**The Ohio State University
Nuclear Reactor Laboratory**

**RE: REQUEST FOR ADDITIONAL INFORMATION REGARDING THE OHIO STATE
 UNIVERSITY RESEARCH REACTOR APPLICATION FOR RE-LICENSING
 (TAC NO. MA7724)**

Proposed Update to Assumptions Used for OSU-NRL Safety Analysis Report (SAR) Section 8.4.4

Top View

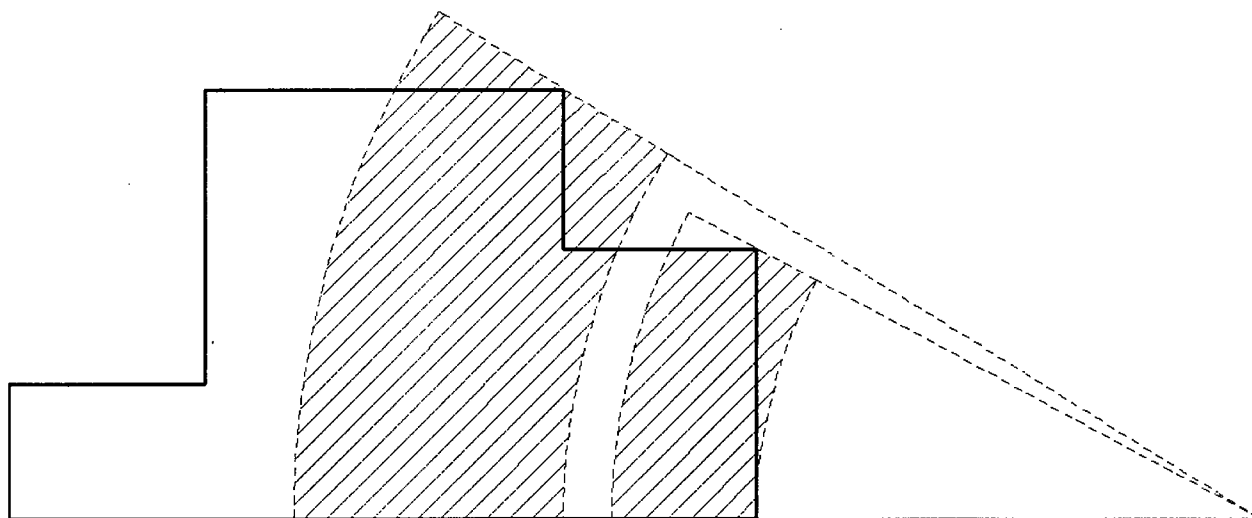
To model direct dose at the controlled-area boundary, we used spherical shapes once again to simplify the calculations via symmetry. As was shown in Section 8.4.4.5 of the SAR, the value of dose from a spherical cloud of an isotope of radius R can be estimated as the dose from an infinite cloud of that isotope multiplied by μR , where μ is the gamma absorption coefficient in air for that isotope. Therefore, the dose from a cloud of radius R_1 is $D_\infty \mu R_1$, where D_∞ is the dose from an infinite cloud. Likewise, the dose from a cloud of radius R_2 is $D_\infty \mu R_2$, and the dose from a spherical shell extending from R_1 to R_2 is $D_\infty \mu (R_2 - R_1)$. The hypothetical maximum dose (dose at the nearest point to the building at the boundary of the controlled area) was modeled as the center of spherical shells, and the reactor building was modeled as sections of the total solid angles of two shells, as seen from the center of the sphere. The size of these sections was determined by the ratio of the areas of building faces by the areas of spheres with radii equal to the distances to the building faces, and the thickness of the shell sections was calculated to make the section volumes equal the building volume. The center of the spherical shells was chosen at the east fence surrounding the building, as that is the

closest point from between building and fence. The figures below show the spherical shell sections superimposed on the building. The solid lines show the outline of the building, and the hatched area show the model's volumes. As can be seen in the figures, this simplification is conservative in that the average distances from the modeled volumes are closer to the point of interest at the fence than the average distance from the actual volume of the building to the fence.

To determine the fraction of total solid angle, we divide the surface area of the facing building wall by the surface area of a sphere with the radius of the inner shell

$$F_8 = \frac{\text{height} \cdot \text{width}}{4\pi R_1^2} = \frac{6.7\text{m} \cdot 14.6\text{m}}{4\pi(12.5\text{m})^2} = 0.0500$$

To determine the outer radius for this shell section, we can integrate the calculated fraction of solid angle between the two radii and set this equal to the desired volume. The volume of the portion of the building being modeled as the inner shell is 471 m³, so this integral is:

$$471 \text{ m}^3 = \int_{R_1=12.5\text{m}}^{R_2} 0.0500 \cdot 4\pi r^2 \cdot dr$$

This equation is solved to yield $R_2 = 16.1$ m.
